Appendix A

Comment Submissions received from Tribes and Agencies

In future correspondence please refer to:
Project Tracking Code: 2018-02-01251
Property: Tacoma Dome Link Extension
Re: Draft Programmatic Agreement Review Comments

RE: Draft EIS Comment - TDLE

FIGURE ES-6
South Federal Way Segment Alternatives

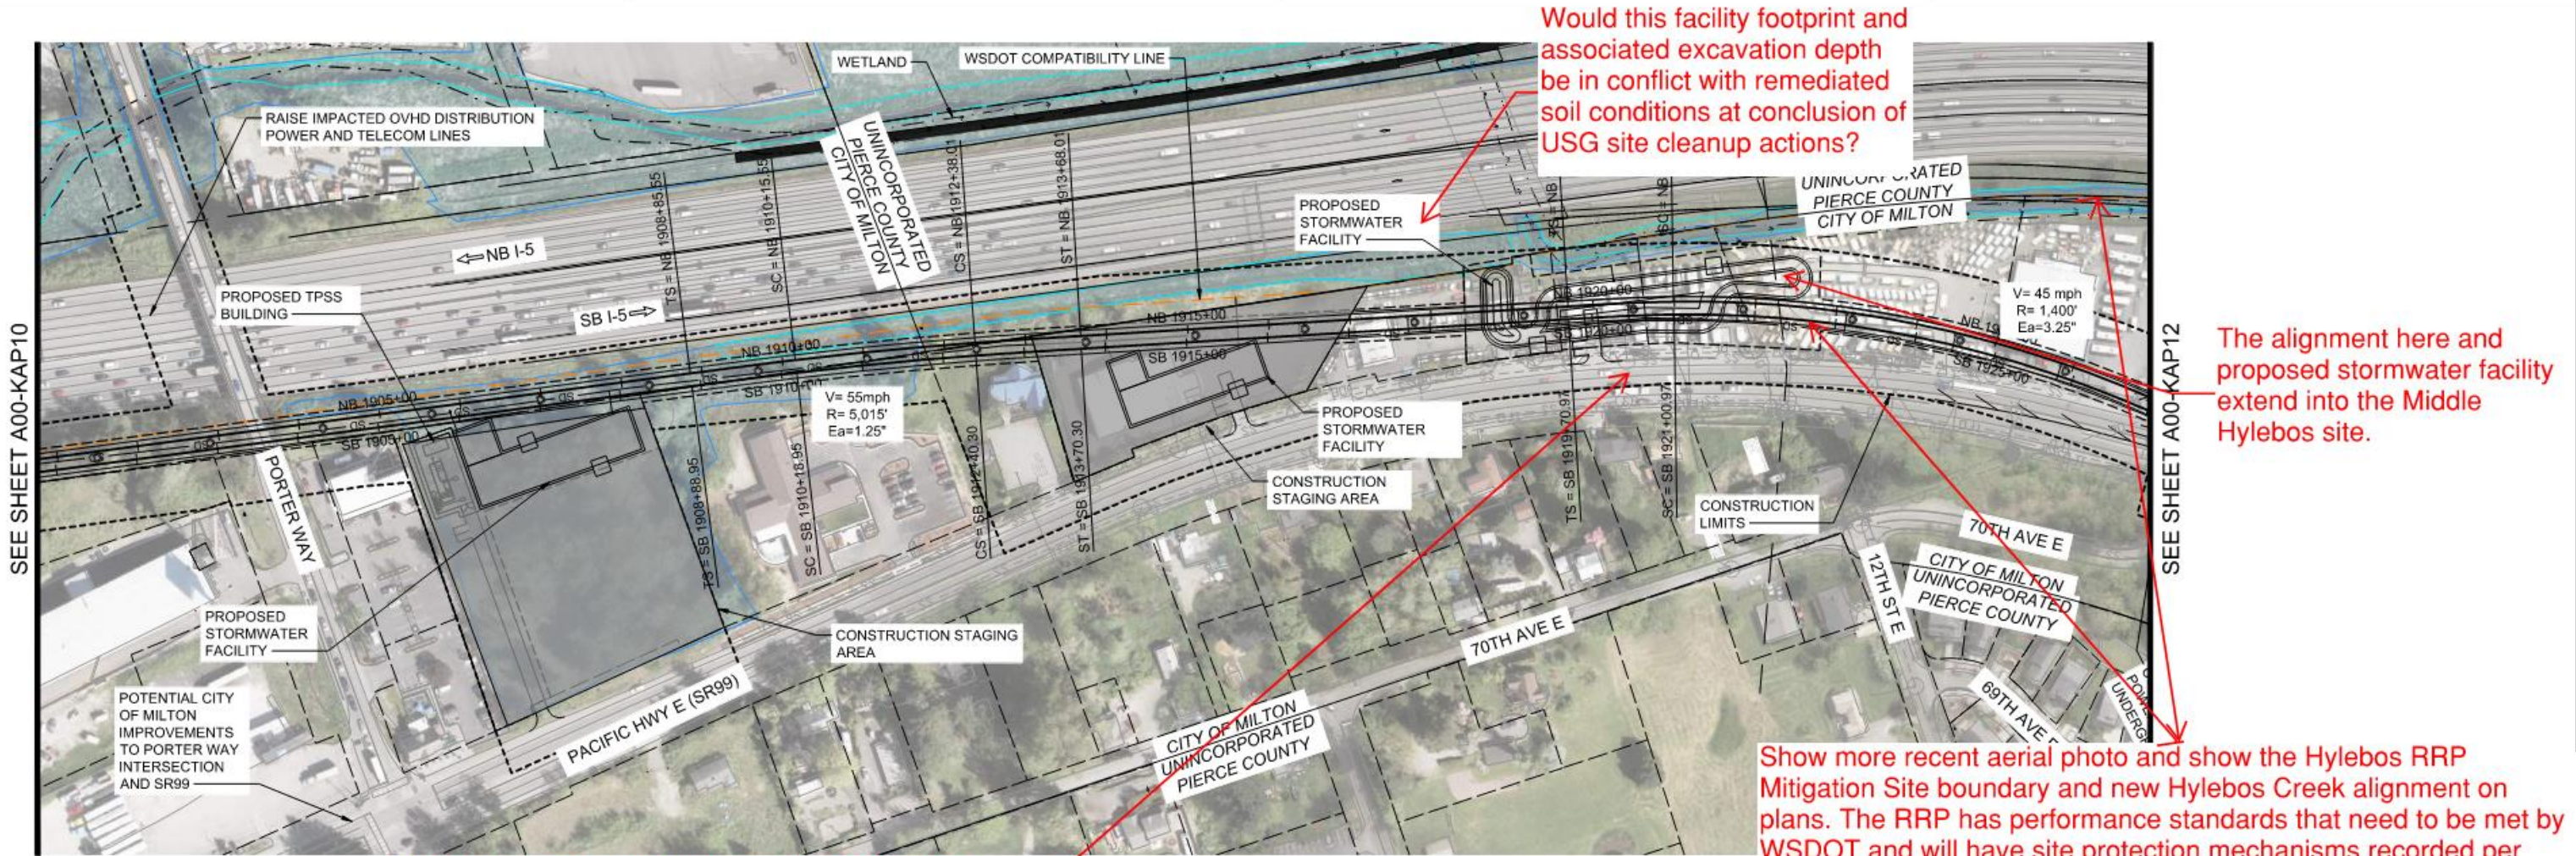
36	Executive Summary	ES-18	Figure ES-6	[See attached marked up figure] What alternatives were considered to avoid impacts to WSDOT's Hylebos RRP Mitigation Site?	Vivian Erickson, WSDOT SR 167 Completion Project
37	Executive Summary	ES-18	Figure ES-6	[See attached marked up figure] Consider shifting the Fife/South Federal Way Segment line here to be closer to the eastern extent of the Fife city boundary and to include WSDOT's Hylebos RRP Mitigation Site impacts analysis within the Fife segment of the DEIS discussion. This is a confusing area as this section of SR 99 is unincorporated Pierce County (Fife limits are from east side of SR 99).	Vivian Erickson, WSDOT SR 167 Completion Project
38	Executive Summary	ES-22		See prior comment on Figure ES-6 regarding location of segment line. Impacts to Hylebos Creek would be more appropriately discussed in the Fife Segment of the DEIS.	Vivian Erickson, WSDOT SR 167 Completion Project

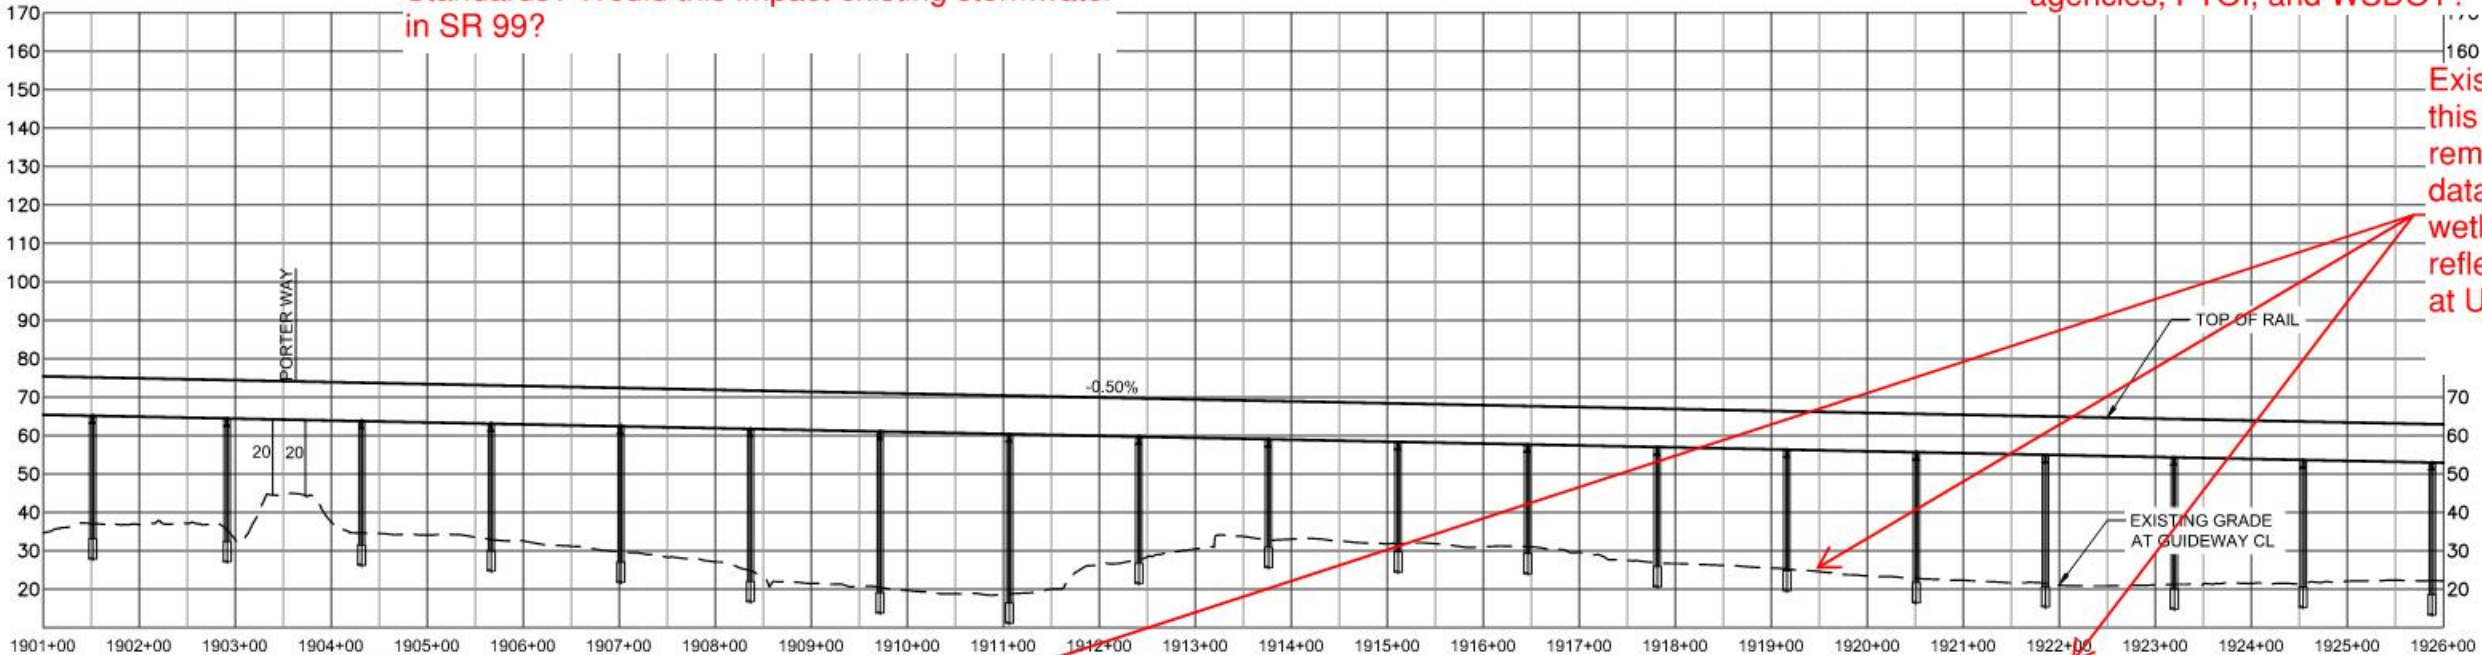
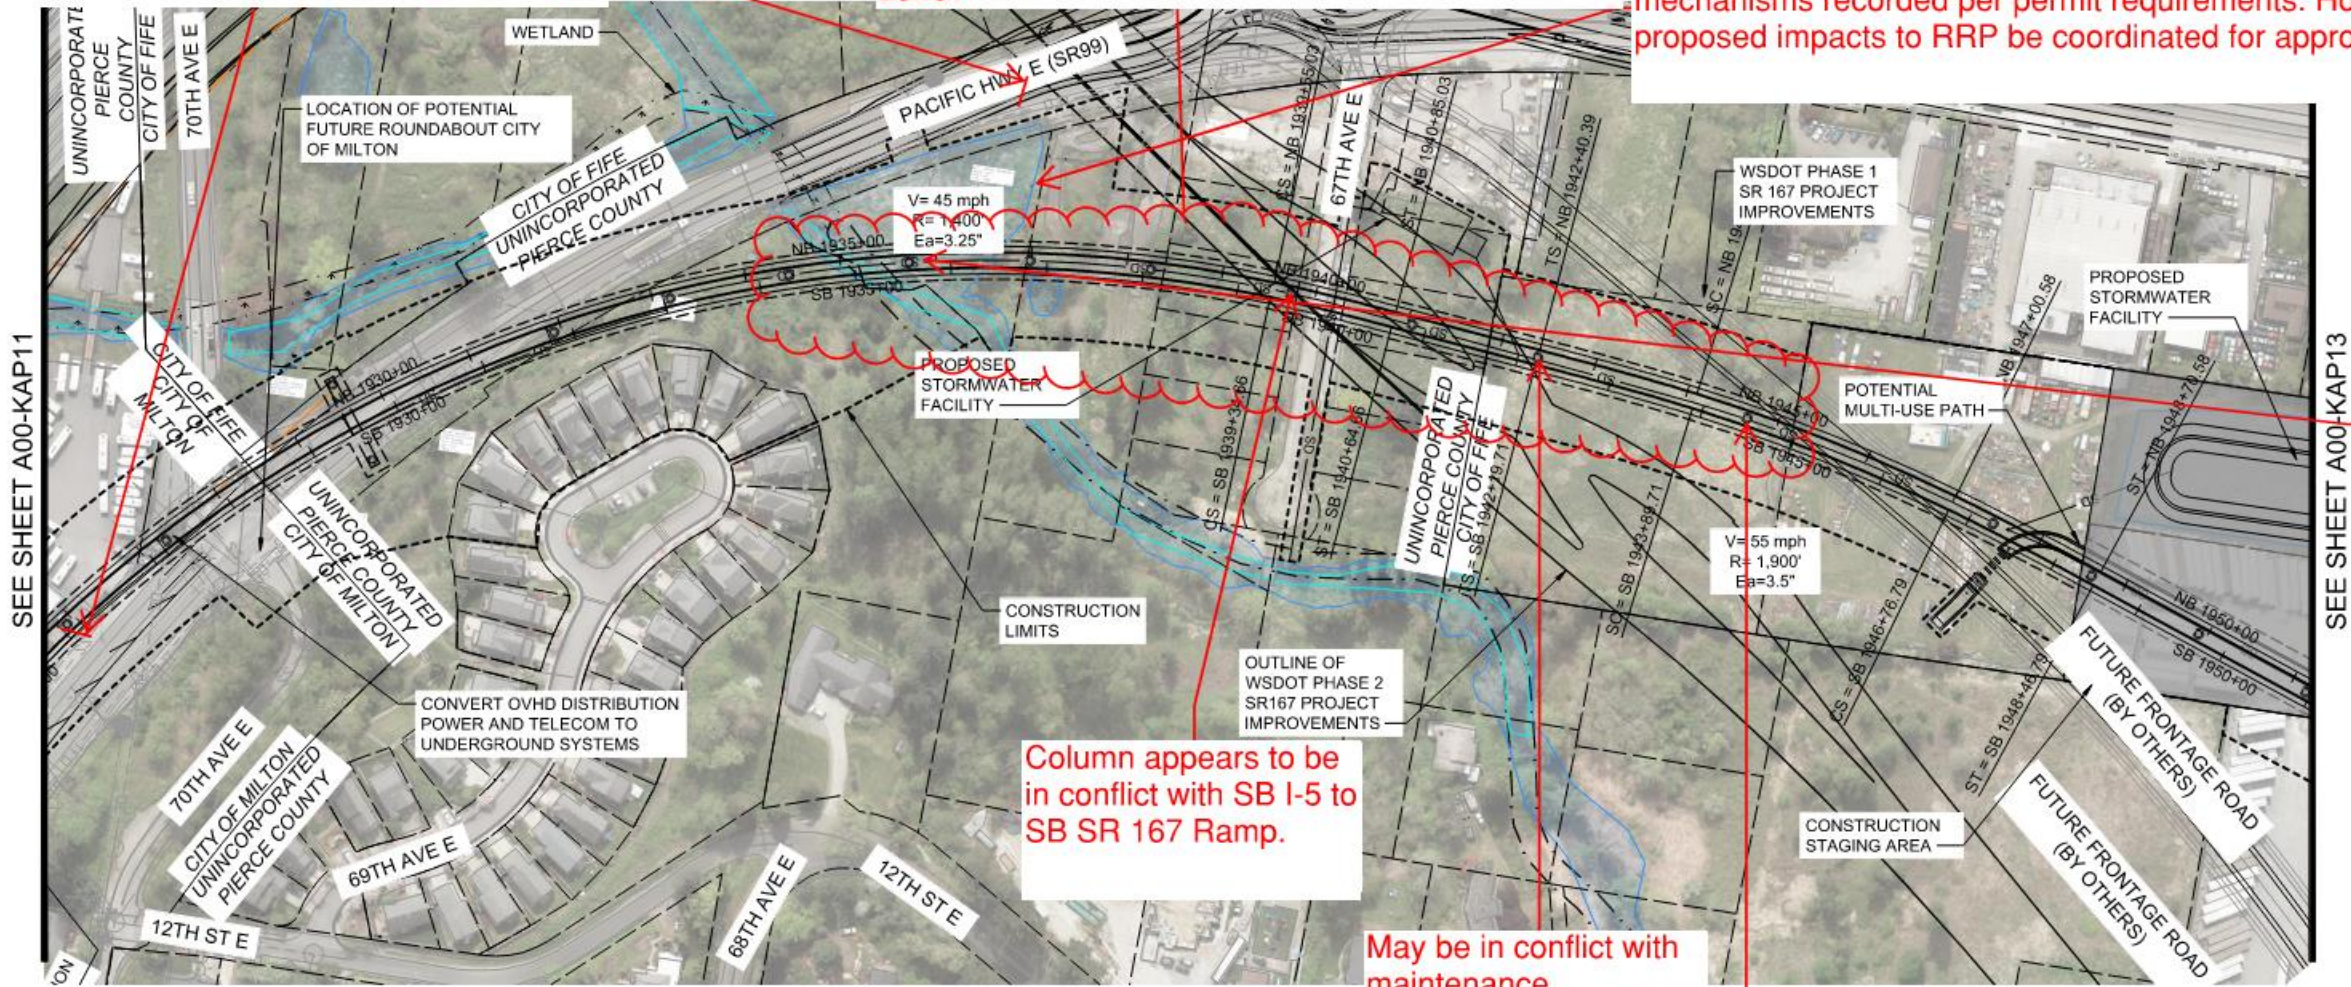
Would this alignment include improvements along the SR 99 frontage to build out per Milton Standards? Would this impact existing stormwater in SR 99?

WSDOT will be replanting this corridor as part of SR 167 Stage 1b Project. Will plants need to be redone by Sound Transit if within their overhead guideway zone?

Show more recent aerial photo and show the Hylebos RRP Mitigation Site boundary on plans. The RRP has performance standards that need to be met by WSDOT and will have site protection mechanisms recorded per permit requirements. How will impacts to RRP be avoided? Or how will proposed impacts to RRP be coordinated for approval through agencies, PTOI, and WSDOT?

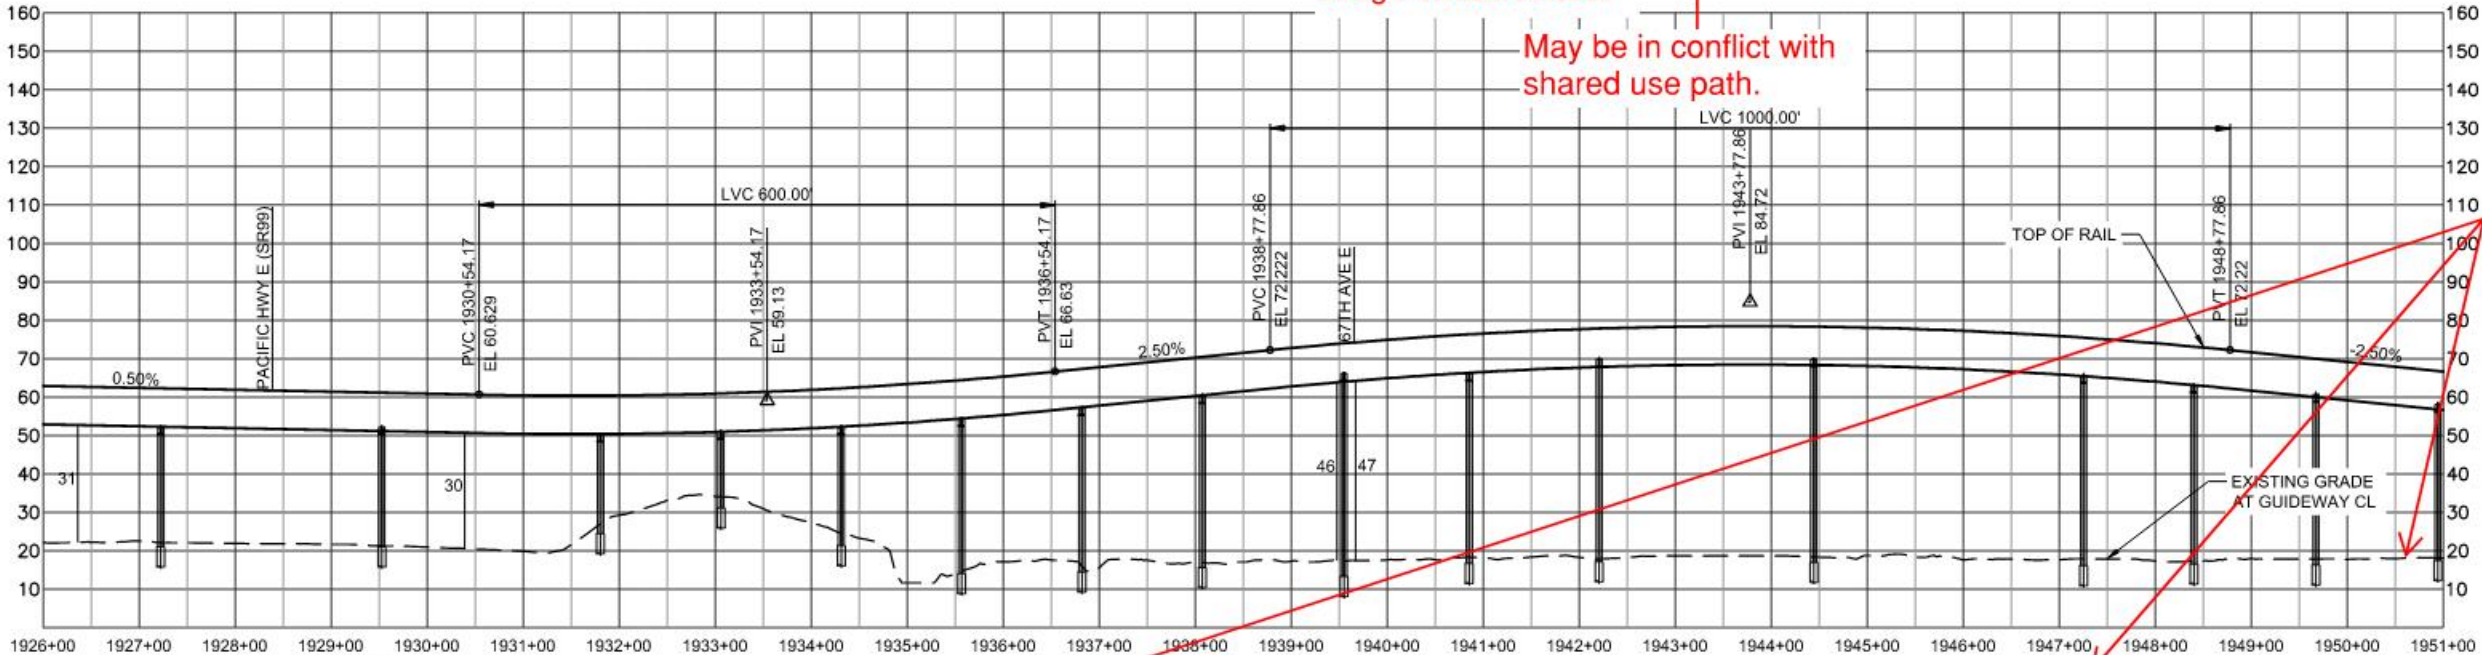
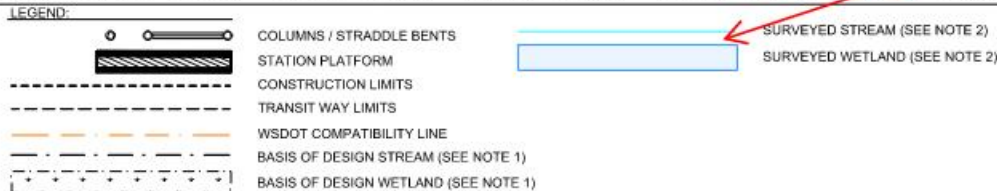
This portion of the alignment crosses Lower Hylebos South Hylebos RRP site and the shown support column may be in conflict with realigned Hylebos Creek. If the alignment doesn't change, it should clear span the mitigation site and minimize wetland, buffer, and floodplain impacts. What is the height of the structure in this location? Will shading impacts be an issue?

Column appears to be in conflict with SB I-5 to SB SR 167 Ramp.

May be in conflict with maintenance pullout/drainage/signall & sign infrastructure.

May be in conflict with shared use path.
